MACPROFESSIONALS SP 11-06

Consideration of the request of Nadlan 32 LLC for Preliminary Site Plan and Stormwater Management Plan approval. The subject property is located at 30275 Hudson Drive, at the southwest corner of Cartier Drive and Hudson Drive, in Section 4 of the City. The property totals 3 acres and the applicant is proposing interior renovations and landbanked parking.

PLAN REVIEW CENTER REPORT

SP #11-06

ALTERNATIVE SITE PLAN

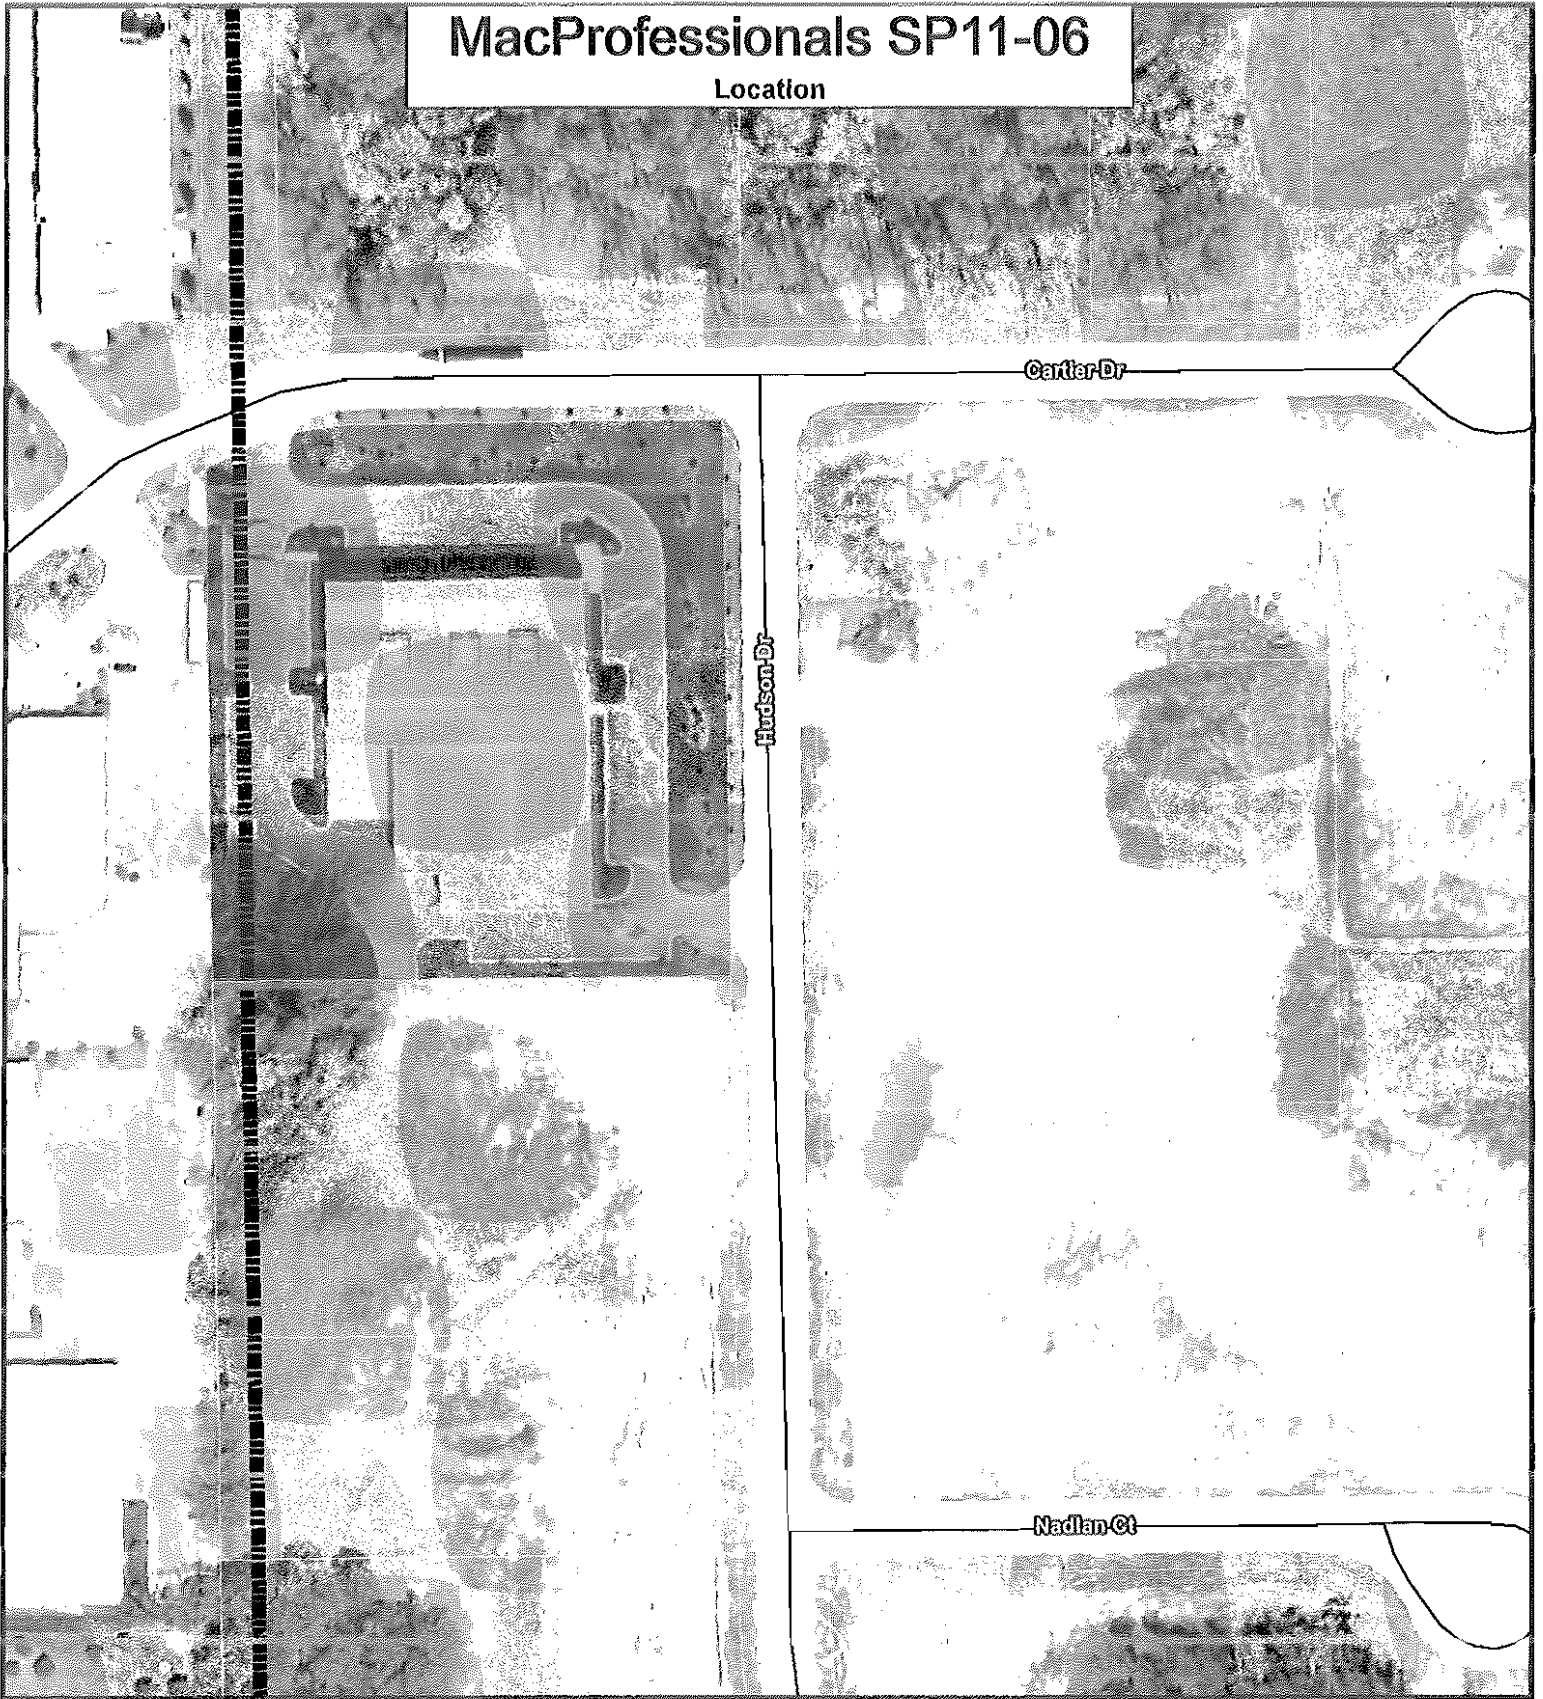
Per your meeting with Ryan at your office please see attached a sketch of Macprofessionals showing future parking expansion up to 128 parking spaces. Should a variance not be granted at the zoning meeting we will implement this drawing.
